Product Announcement

Models: Greenstar Boilers

Brand: Bosch

Subject: Product Update

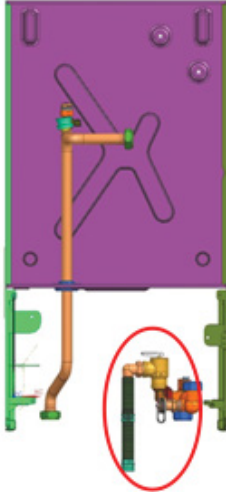
Greenstar boilers have been updated to include a larger diameter pipe leading to the pressure relief valve. This is to eliminate potential confusion in local code interpretations. The diameter of the piping has increased from 18mm to 22mm. (see fig. 1). Replacement parts have been updated to include new part numbers and are not backwards compatible to fit older units.

Piping Details - Wall Boiler

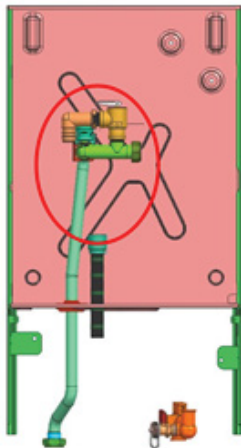
The PRV has been moved from the bottom of the boiler to the top with the discharge hose extended.

Spare part current piping FD<1st.Feb.2022

Spare part new piping from FD>1st.Feb.2022
